Subject: AP1000 COL Standard Technical Report Submittal of APP-GW-GLN-114, (TR 114),
Revision 0

“AP1000 Auxiliary Boiler Sizing and Design”

Technical Report 114

Chapter 10 of the Design Control Document (DCD) describes the AP1000 Auxiliary Steam System Design. Westinghouse has modified this design to alleviate issues in current plants related to operational problems due to fuel fouling in diesel-fired boilers in stand-by service. This report summarizes changes to the design, and includes the DCD (reference 1) mark up.

Figure 2.6.1-1

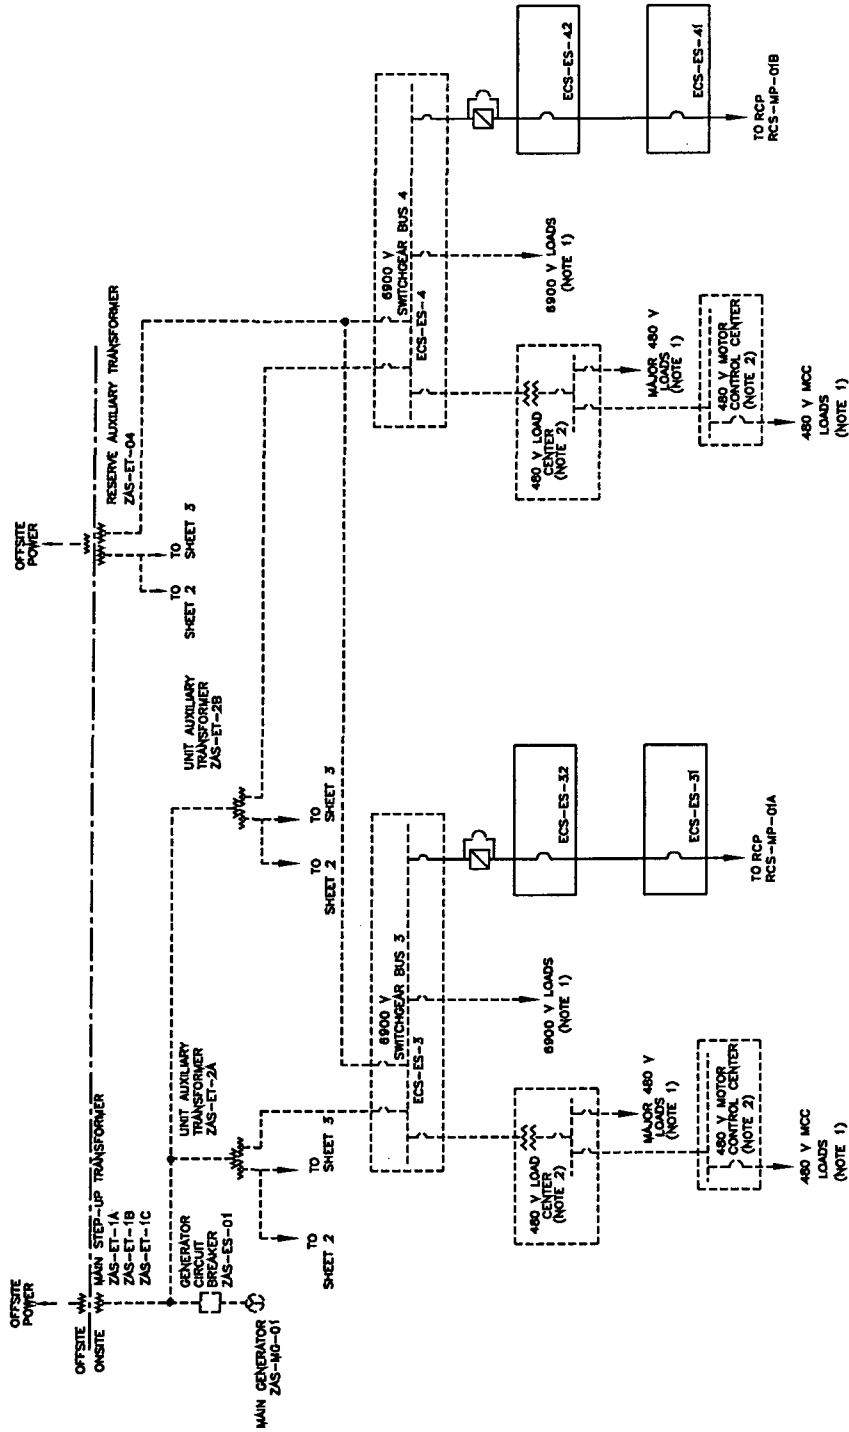
2. The fuel oil pumps, ducting and fans associated with the diesel fired boiler will be removed from the turbine building.
3. A 25 MW electric boiler will be installed in the boiler room of the turbine building along with its associated electrical equipment including:

- a. Load center
 - b. Switchgear
 - c. MCC

Note: A third UAT (Sized to supply the 25 MVA boiler + up to 8 MVA additional for other site specific loads) will be located outside the turbine building in the transformer area.

Figure 8.3.1-1

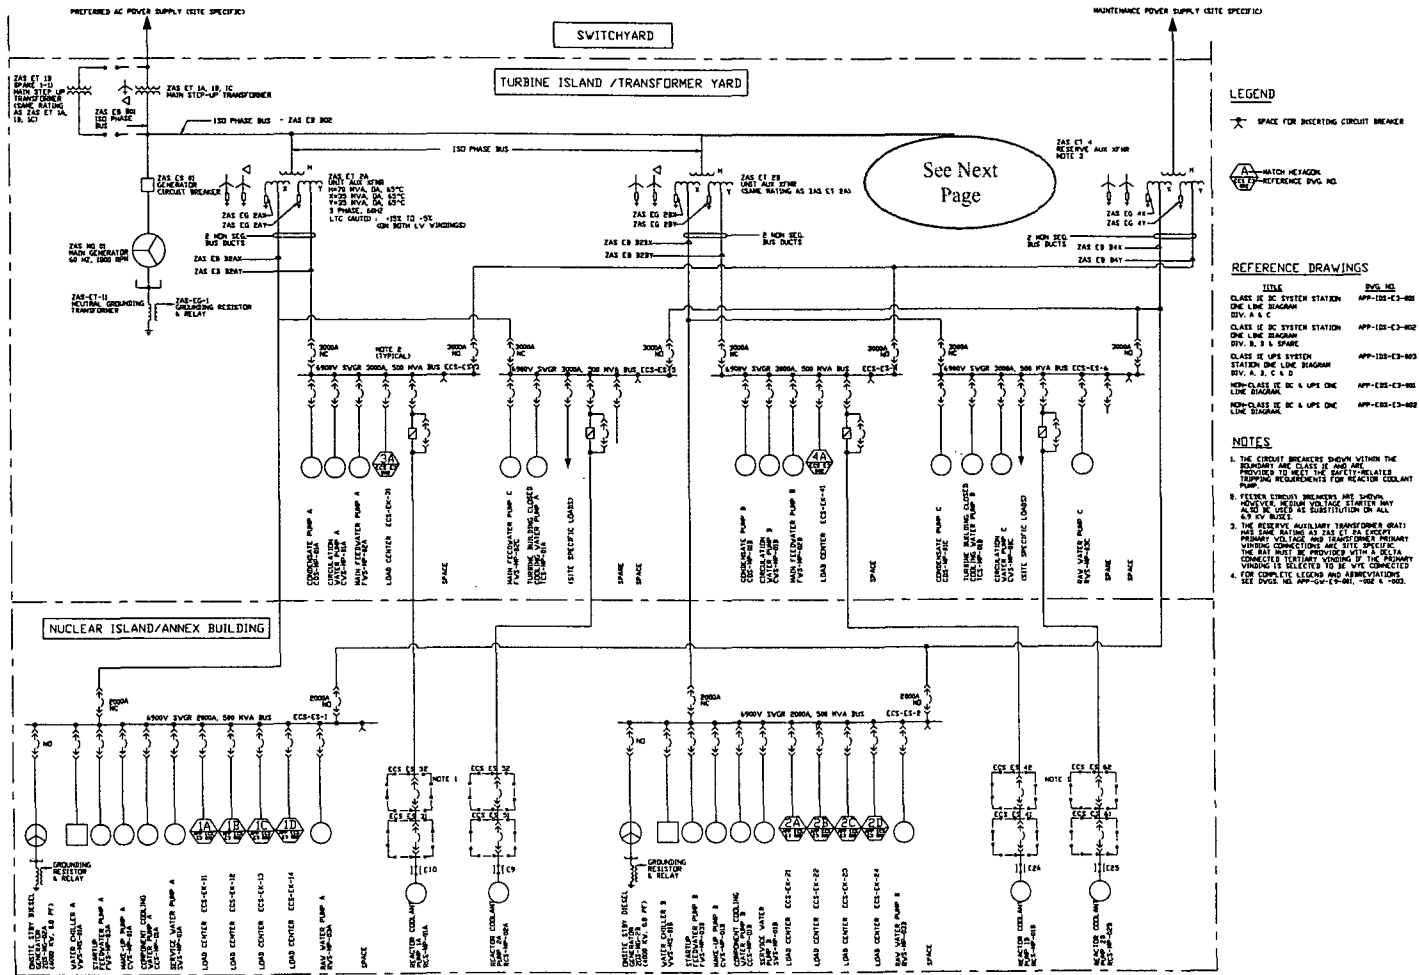
The two unit auxiliary transformers have two identically rated 6.9 kV secondary windings. **The third UAT is a two winding transformer sized to accommodate the electric boiler and site specific loads.** Secondaries of the auxiliary transformers are connected to the 6.9 kV switchgear buses by nonsegregated phase buses. The primary of the unit auxiliary transformer is connected to the main generator isolated phase bus duct tap. The 6.9 kV switchgear designation, location, connection, and connected loads are shown in Figure 8.3.1-1. The buses tagged with odd numbers (ES1, ES3, etc.) are connected to one unit auxiliary transformer and the buses tagged with even numbers (ES2, ES4, etc.) are connected to the other unit auxiliary transformer. **ES7 is connected to the third UAT.** These 6.9 kV buses ES1-ES6 are provided with an access to the maintenance source through normally open

The arrangement of the 6.9 kV buses permits feeding functionally redundant pumps or groups of loads from separate buses and enhances the plant operational flexibility. The 6.9 kV switchgear powers large motors, and the load center transformers. There are two switchgear (ES1 and ES2) located in the annex building, and ~~four~~ five (ES3, ES4, ES5, ES6 and ES7) in the turbine building.

Figure 9.5.4-1 (Sheet 1 of 3)

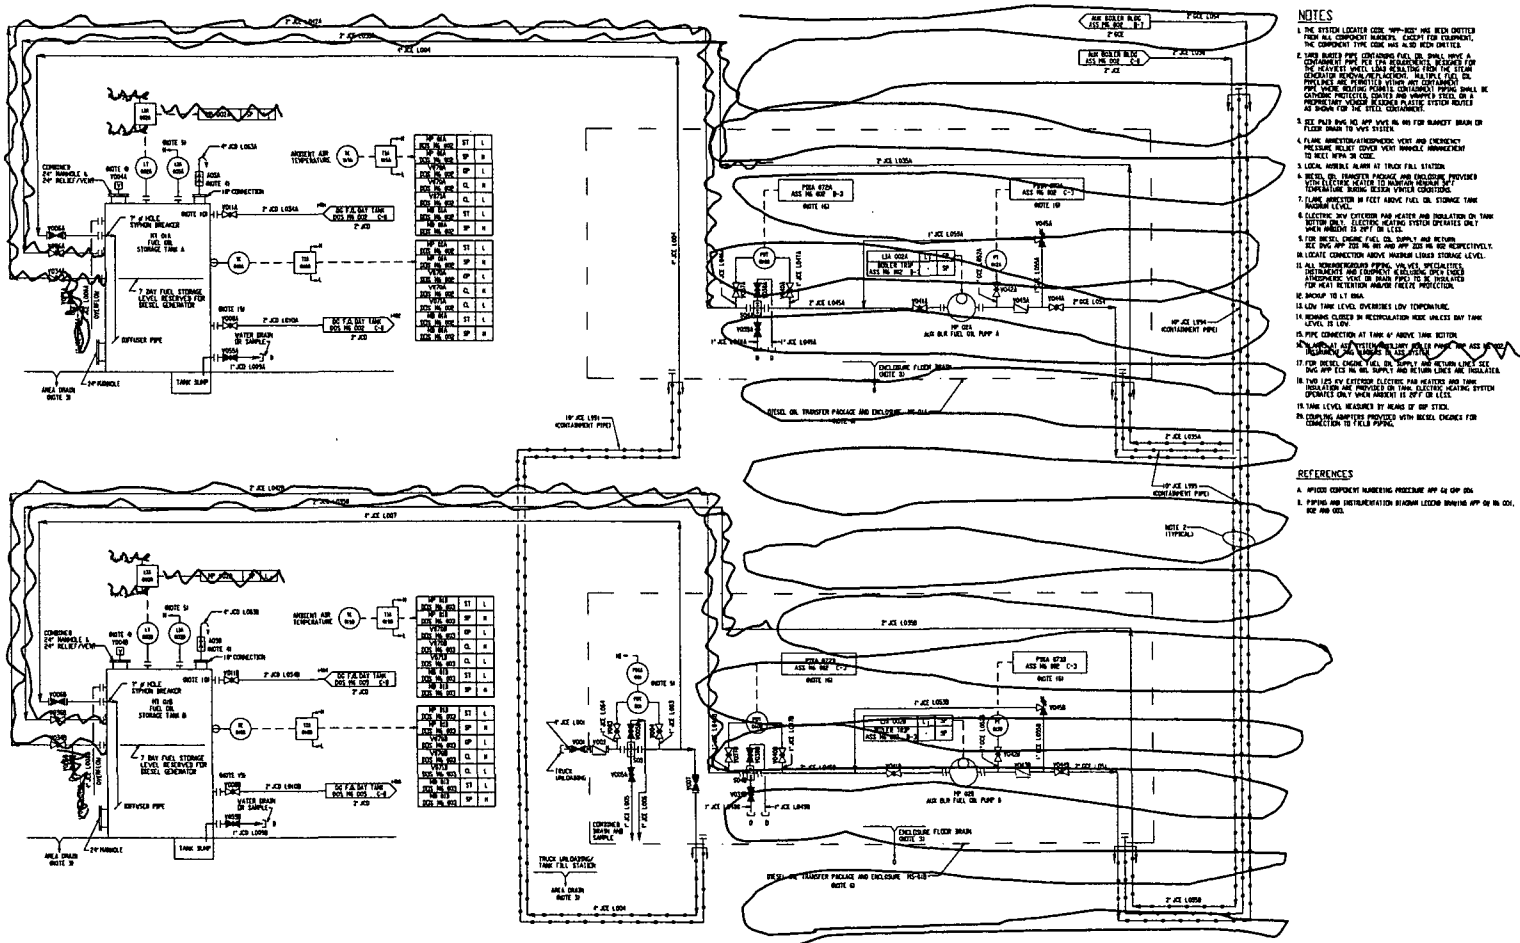
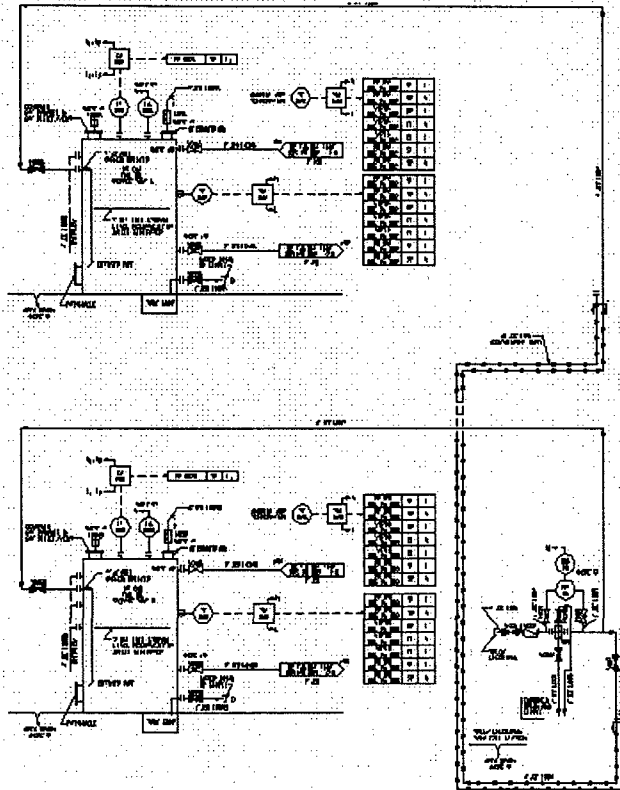
Title of Figure 9.5.4-1 sheets 1, 2 and 3

The standby diesel ~~and auxiliary boiler~~ fuel oil system is shown in Figure 9.5.4-1. The system consists of two fuel oil storage tanks, a diesel generator fuel oil transfer system, ~~an auxiliary boiler fuel oil supply system,~~ and an ancillary diesel generator fuel oil supply system.

This is Figure 9.5.4-1 from the previous page with Aux. Boiler Fuel System Piping and Components Removed.
